Planning Commission - Special Meeting Agenda

Planning Commission
City of Lathrup Village
27400 Southfield Road
Lathrup Village, MI 48076

Planned Unit Development – Panera

Site: 27777 Southfield Road
Applicant: The Lawrence Group
Plan Date: June 14, 2022, July 5, 2022 (site plan only)
Zoning: VC – Village Center District
Parcel ID: 24-14-432-006
Proposal: Planned Unit Development – Restaurant with drive-through

A200-P

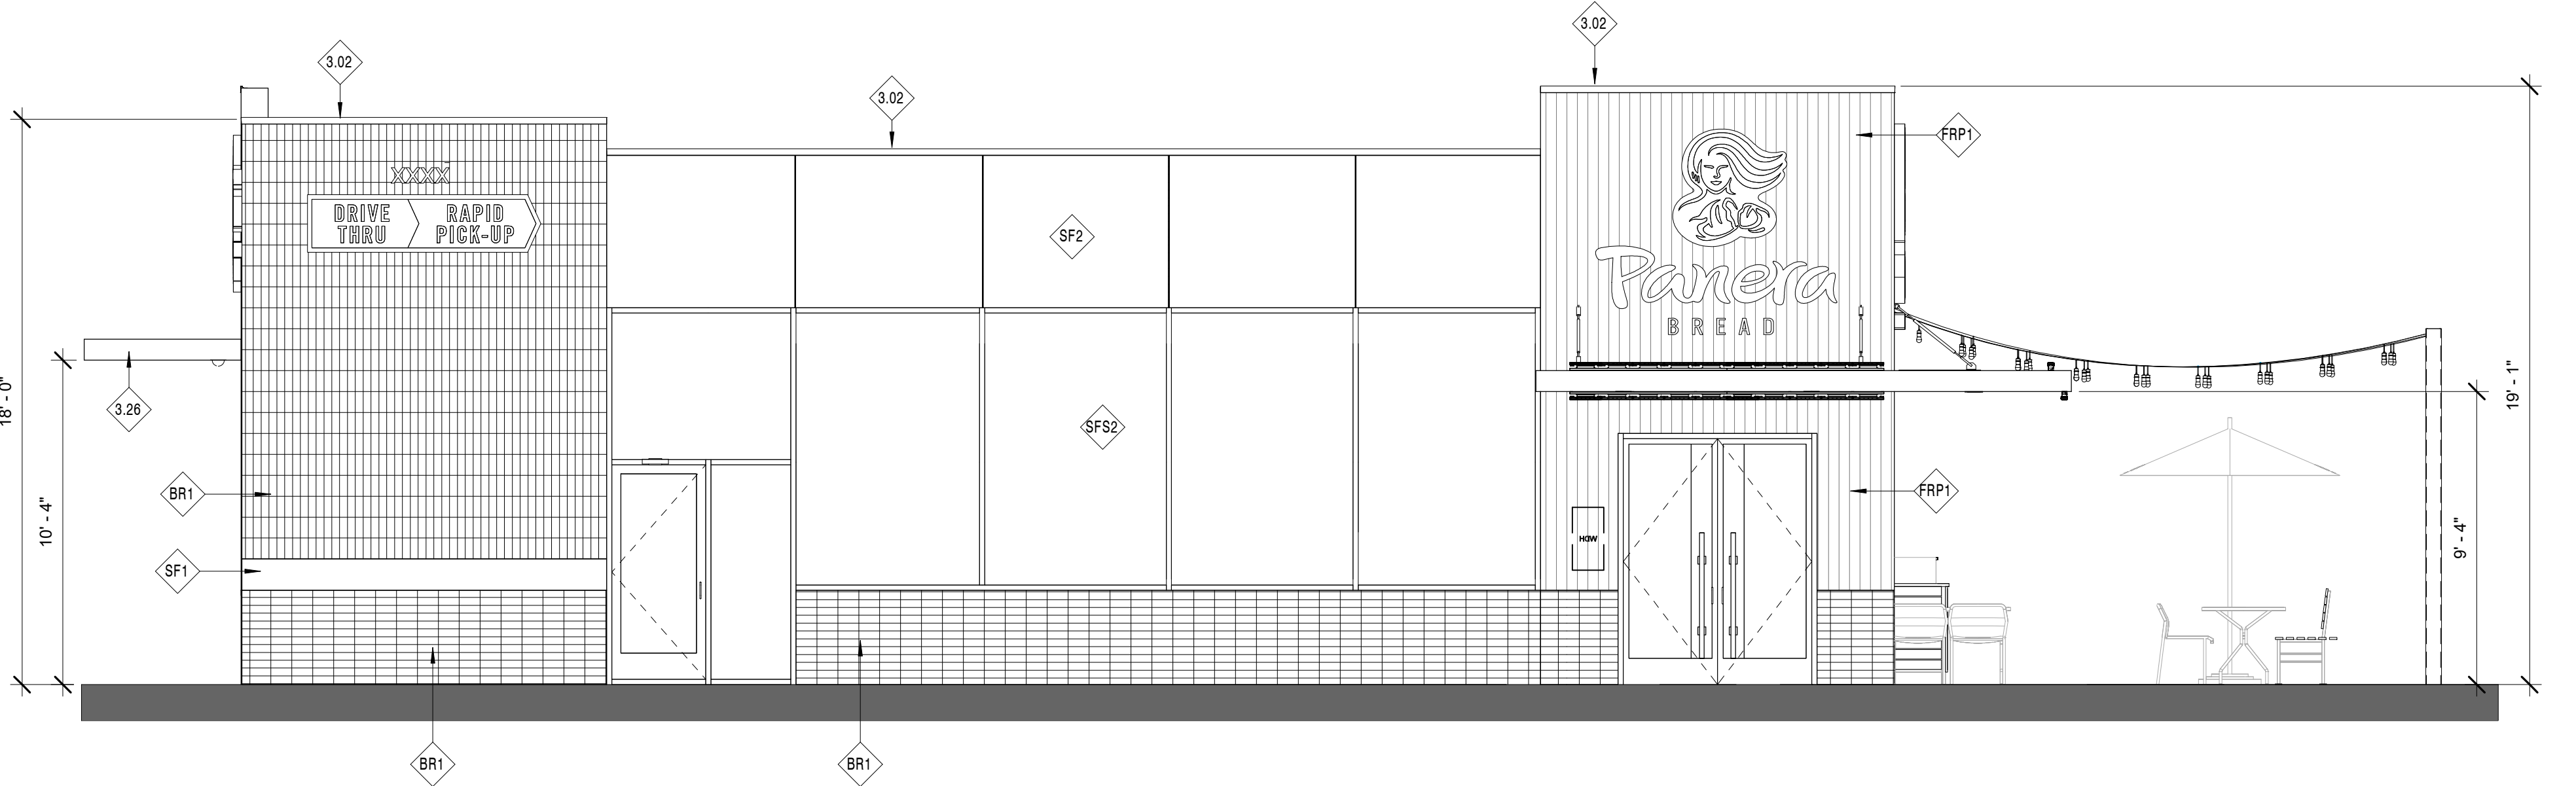
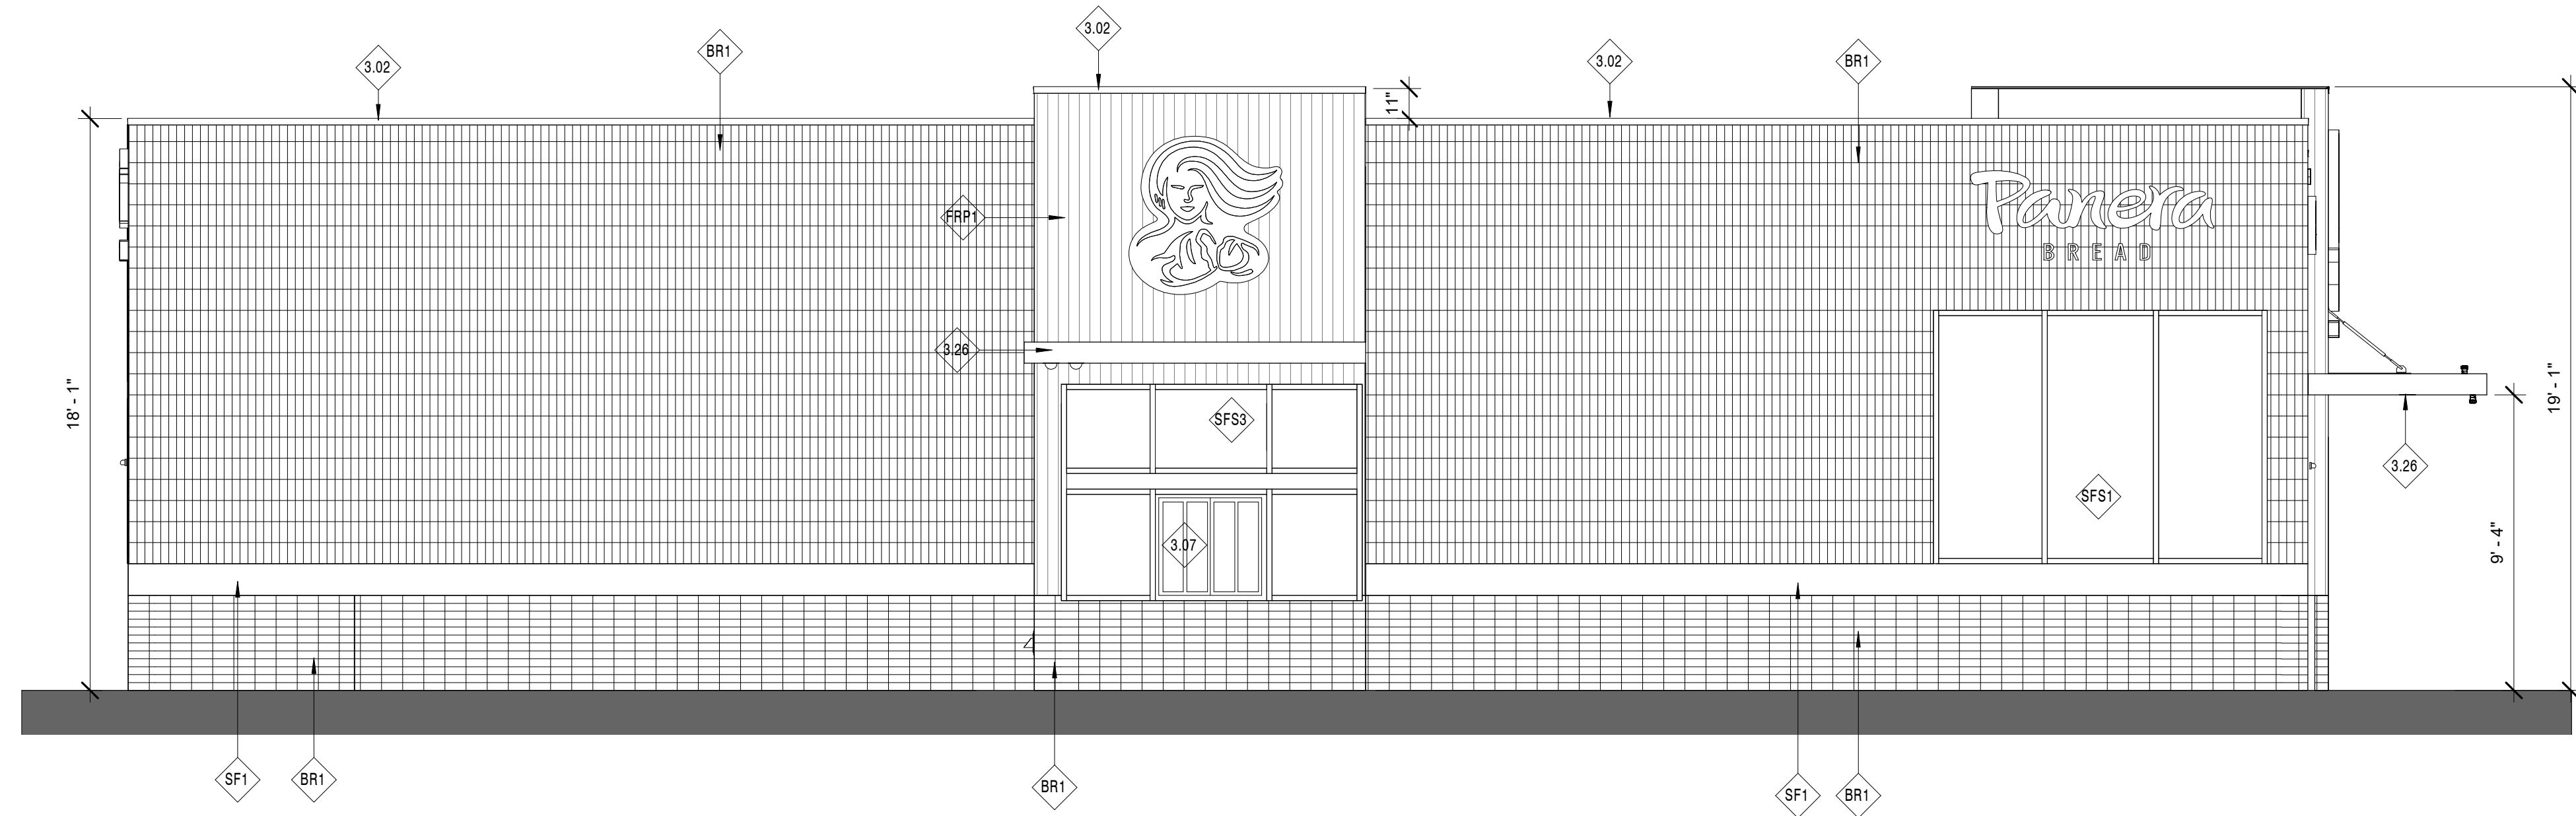
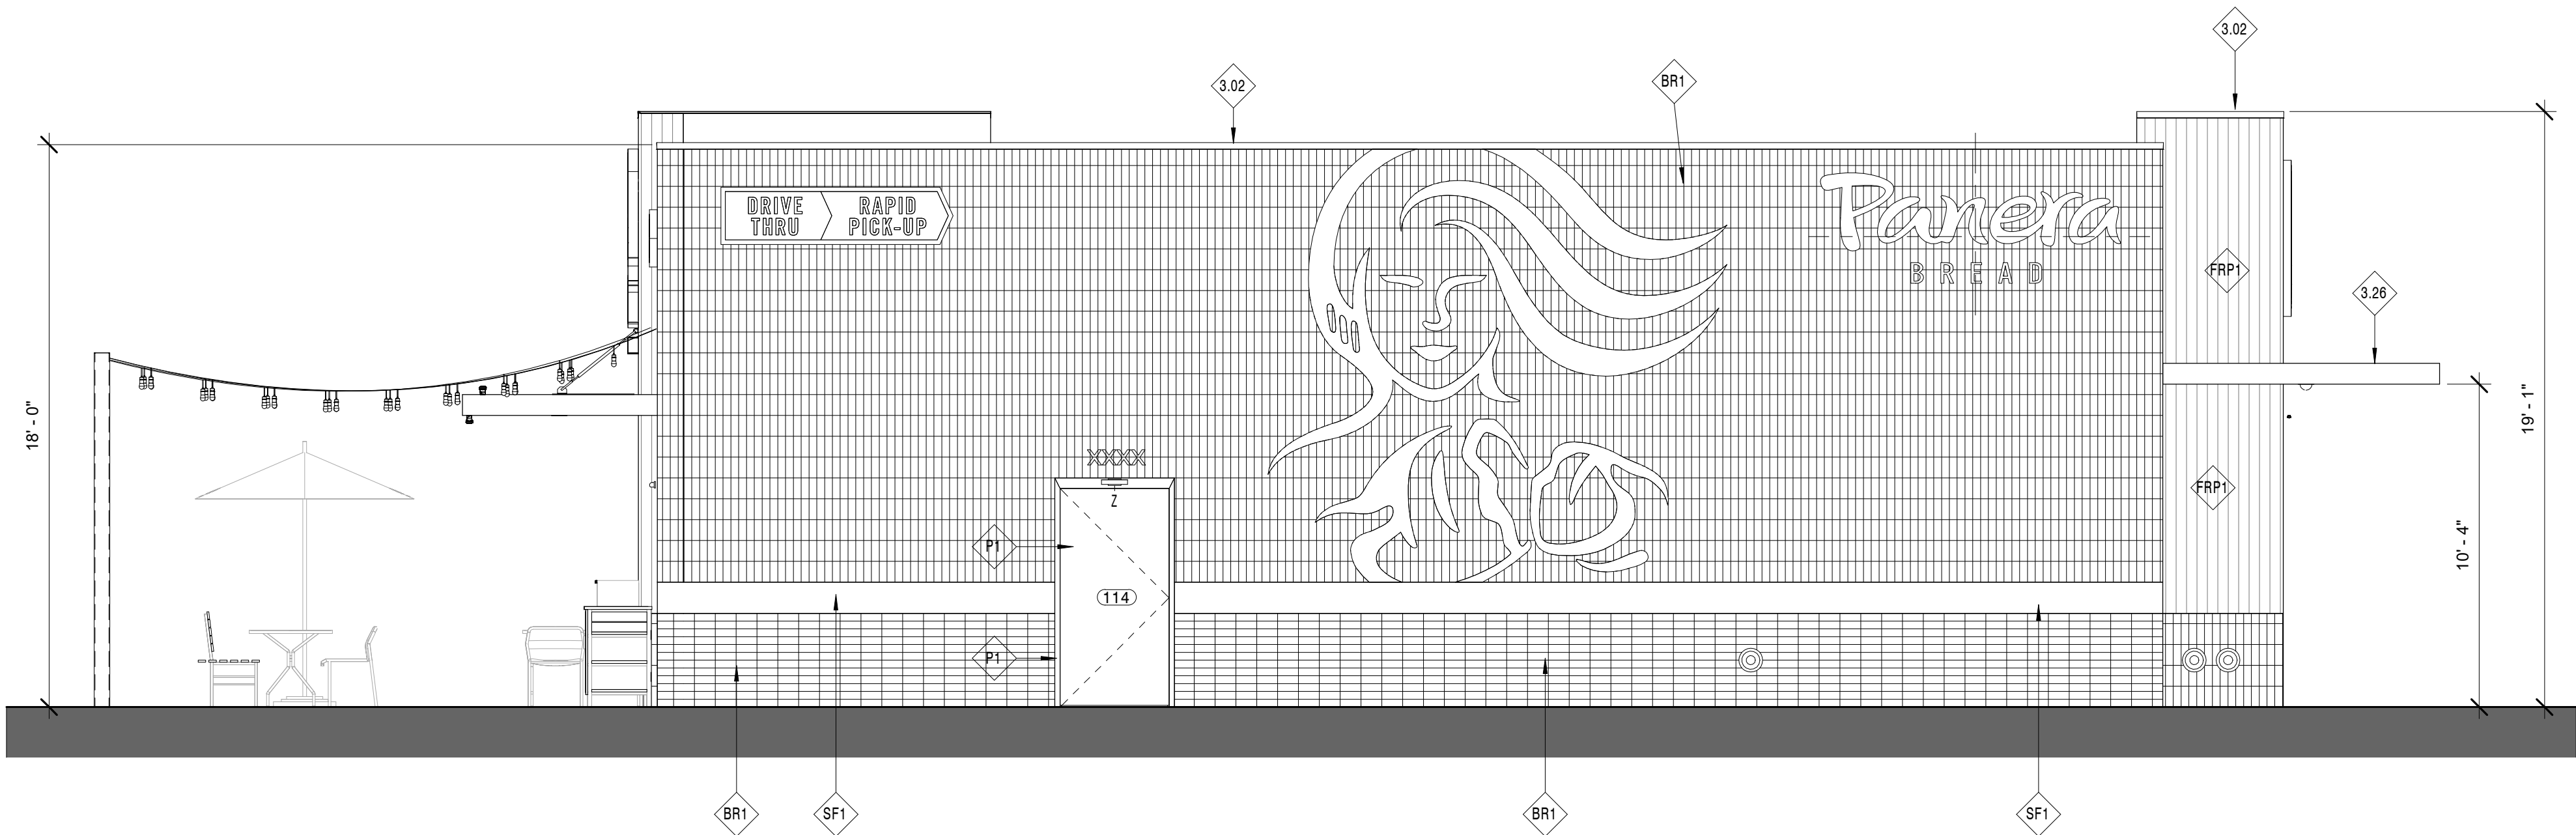
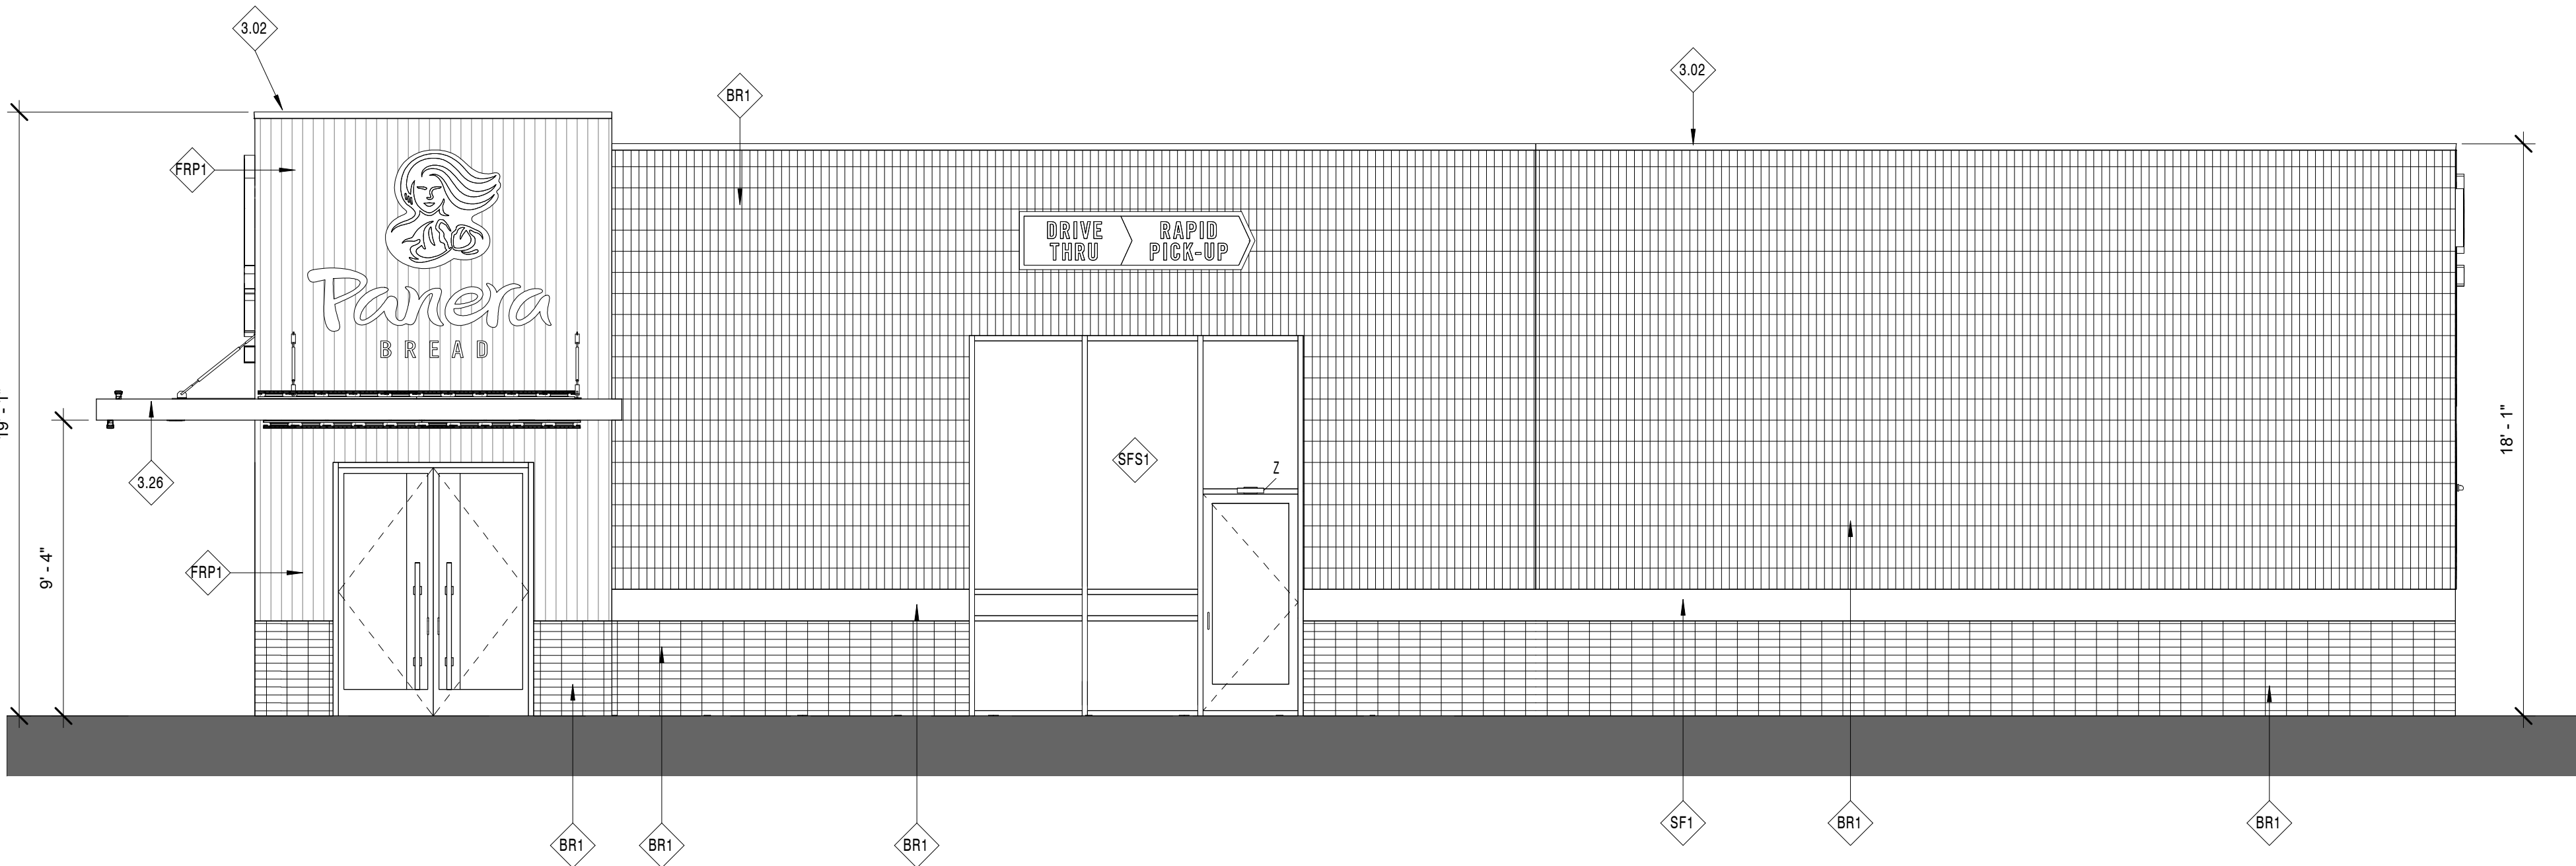
- 1) Facing street, park, or plaza. At least 90% of all exterior building façades facing a street, park, or plaza shall be finished with a combination of two or more of the following: Glass, brick, cut or cast stone, wood, cementitious board (e.g., Hardie Plank), integrally colored concrete units with brick proportions (e.g., half-high "C" brick), and textured stucco. **This standard is met along Southfield Road and Sunset Boulevard; and the applicant has**

- 2) Facing other buildings: at least 70% of the exterior façade shall consist of the materials specified above and may also include split-faced, scored, or fluted block. **The south side of the building contains the drive through window. The applicant has confirmed 90% of the drive-thru side of the building (south façade) is comprised of vertical and horizontal brick, glass, and wood-look metal banding (for longevity & durability while also providing visual interest).**
- 3) Variation: There shall be a change in the vertical or horizontal building plane when there is a change in color or material. Street facing facades shall be divided vertically into segments no greater than sixty (60) feet wide. It appears that this standard is met.

D. Corner Buildings. Buildings located at a street corner shall have appropriate architectural features and details that accentuate its prominent corner location through additional building height and /or adding a building peak or tower element at the corner. Other creative techniques may be used, subject to the acceptance of the Planning Commission. While substantially setback from the build-to zone, the northeast corner of the building at Southfield Road and Sunset Boulevard is accentuated with a distinguished architectural tower. Prominent windows on the east side and the outdoor seating area on the north further address the intent of corner building standards.

NORTH ELEVATION: SCALE: 1/8"=1'-0"

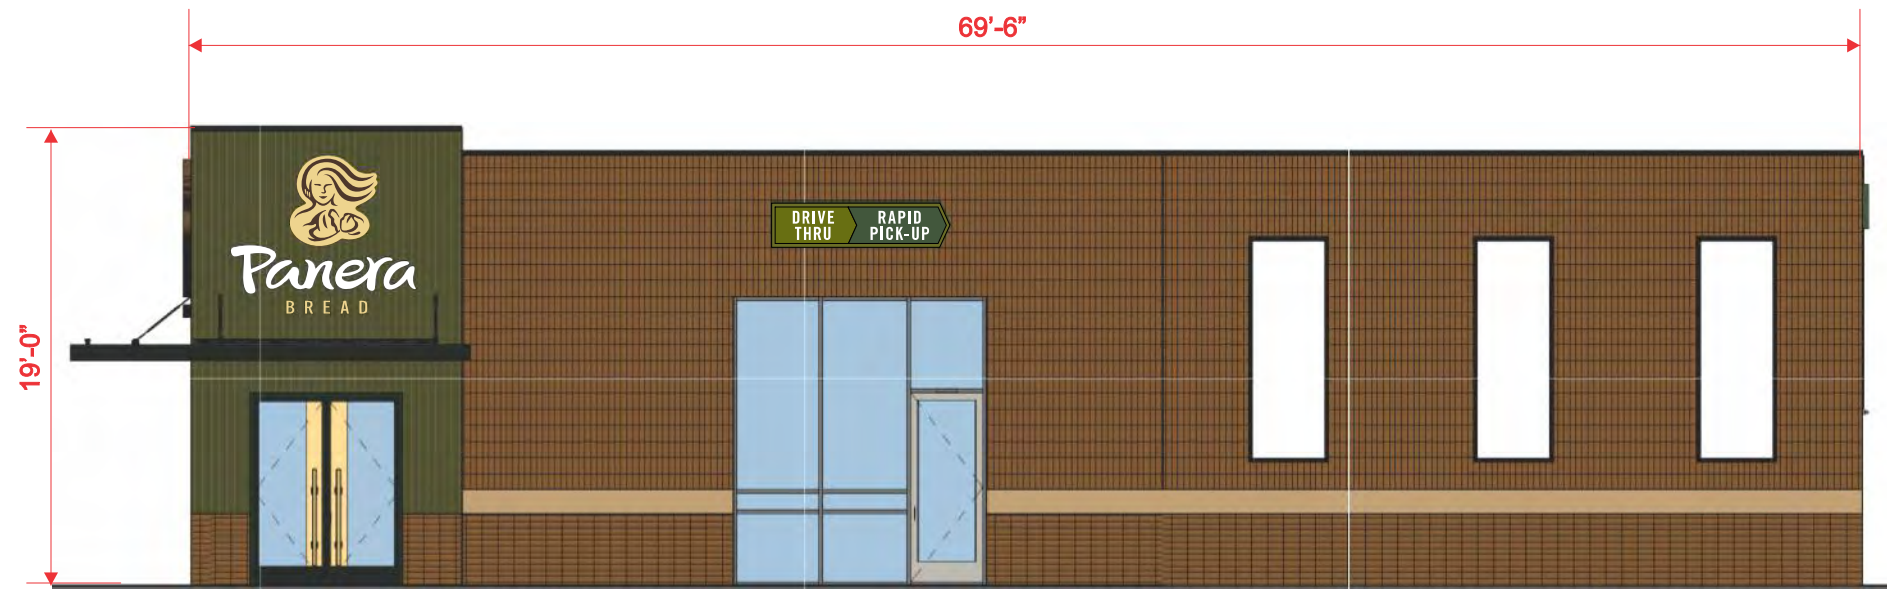
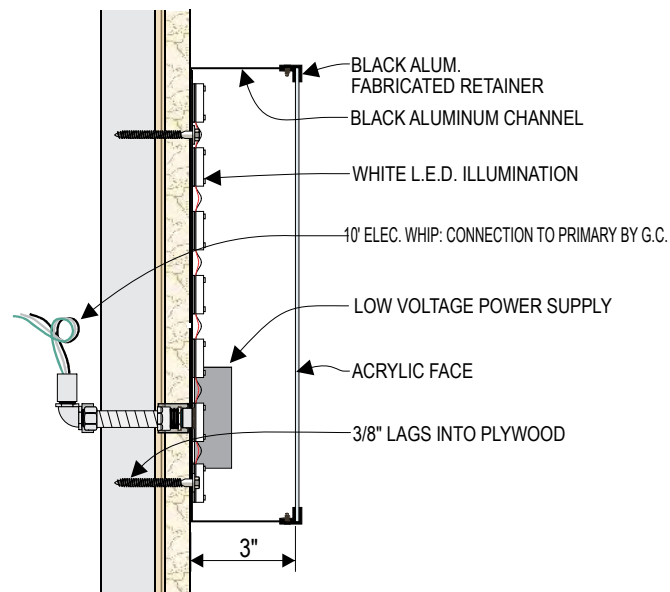
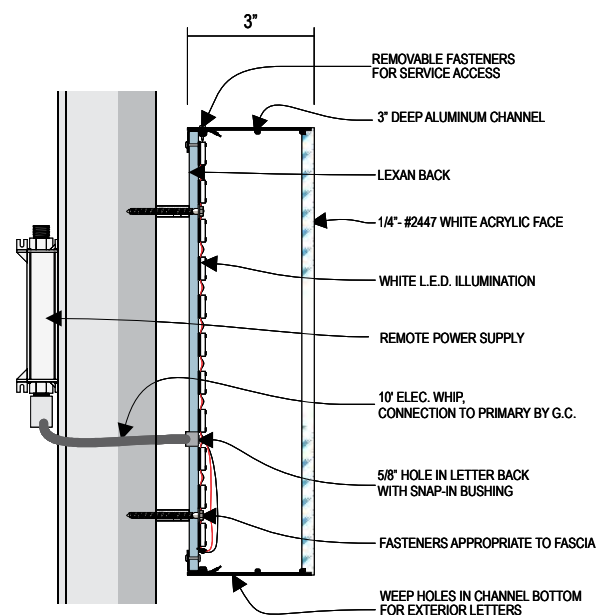
EXCEEDS NUMBER ALLOWED

WEST ELEVATION: SCALE: 1/8"=1'-0"

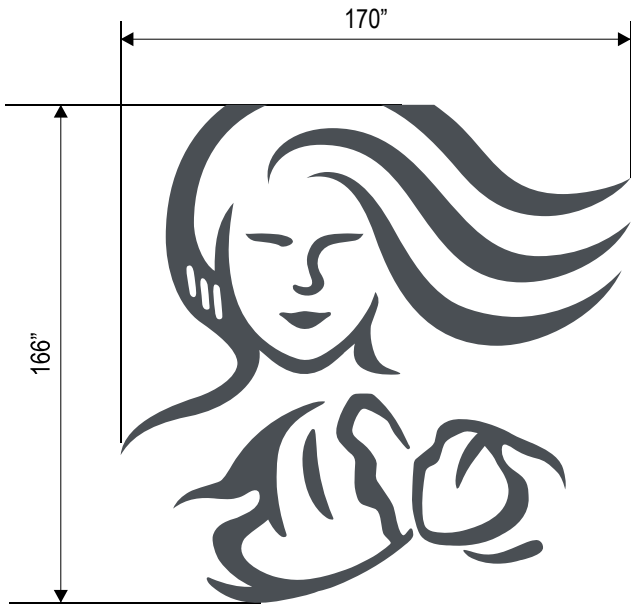
EXCEEDS NUMBER ALLOWED
